SUBJECT: ISSUANCE OF AMENDMENT NO. 73 TO FACILITY OPERATING LICENSE
NO. NPF-2 AND AMENDMENT NO. 65 TO FACILITY OPERATING LICENSE NO.
NPF-8 - JOSEPH M. FARLEY NUCLEAR PLANT, UNITS 1 AND 2, REGARDING
AN INCREASE IN STEAM GENERATOR TUBE PLUGGING LIMIT AND ASSOCIATED
 F_Q CHANGE (TAC NOS. 62283 AND 62284)

SAFETY EVALUATION BY THE OFFICE OF NUCLEAR REACTOR REGULATION

SUPPORTING AMENDMENT NO. 73 TO FACILITY OPERATING LICENSE NO. NPF-2

JOSEPH M. FARLEY NUCLEAR PLANT, UNITS 1 AND 2

Figure 2.1-1 Reactor Core Safety Limit
Three Loops in Operation

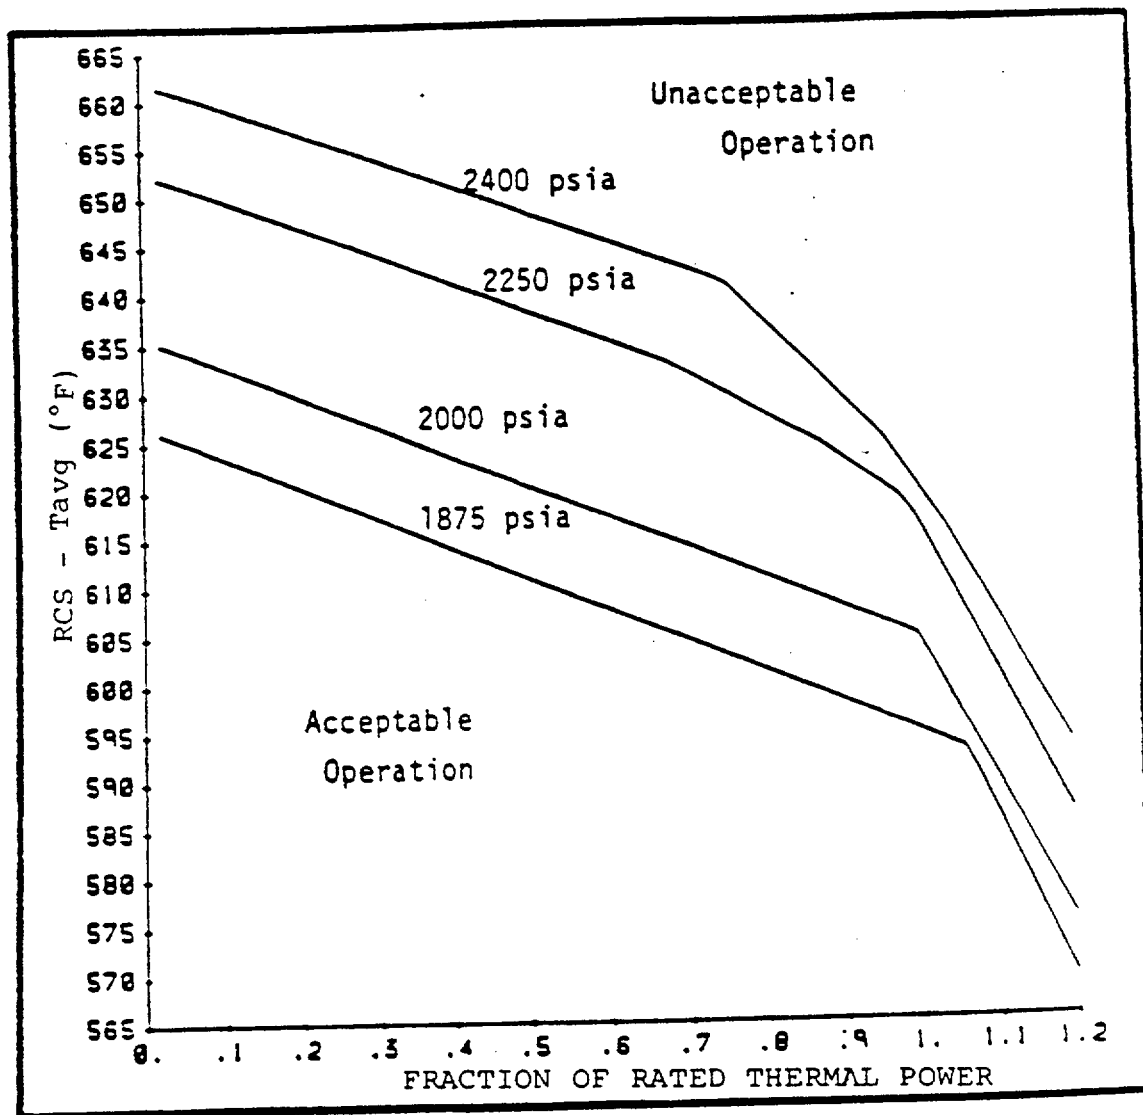
Applicability: $\leq 10\%$ Steam Generator Tube
Plugging

1. In Figure 2.1-1, Reactor Core Safety Limit, applicability was changed to account for the increase in the SGTP limit from 5% to 10%. This was discussed in the evaluation above and is acceptable.
2. In TS 3/4.2.2 Heat Flux Hot Channel Factor - $F_Q(z)$ the value for F_Q was changed from 2.31 to 2.32 for greater than 50% RTP and from 4.62 to 4.64 for less than original to 50% RTP. These changes are acceptable for the reasons explained herein.
3. In TS 3/4.2.1, Bases, Axial Flux Difference, an editorial change was made to account for the new F_Q value of 2.32 instead of 2.31. This is acceptable.

Figure 2.1-1 Reactor Core Safety Limit
Three Loops in Operation

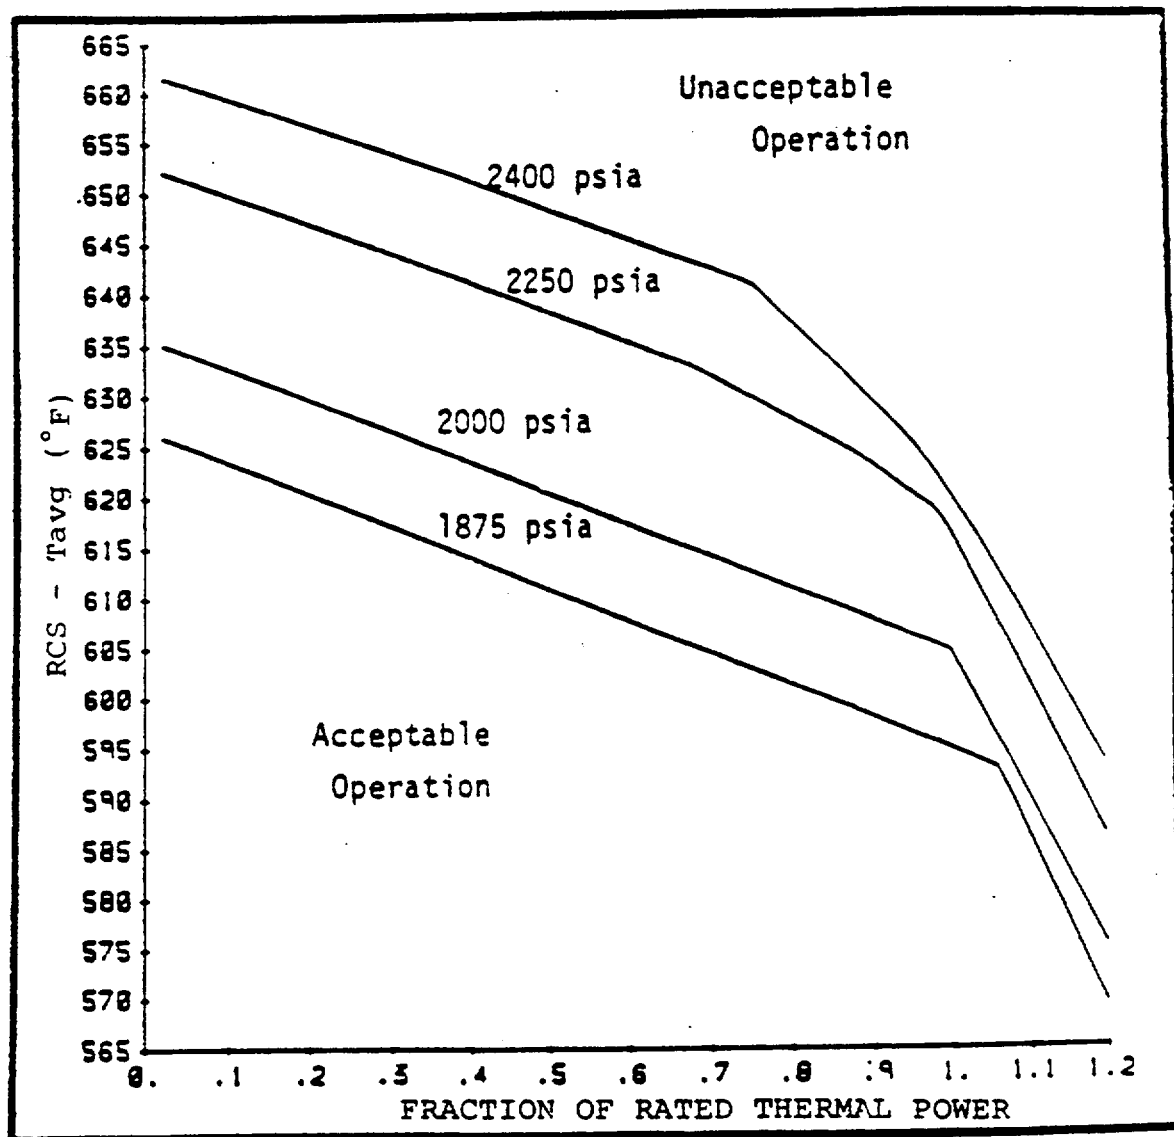
Applicability: $\leq 10\%$ Steam Generator Tube
Plugging
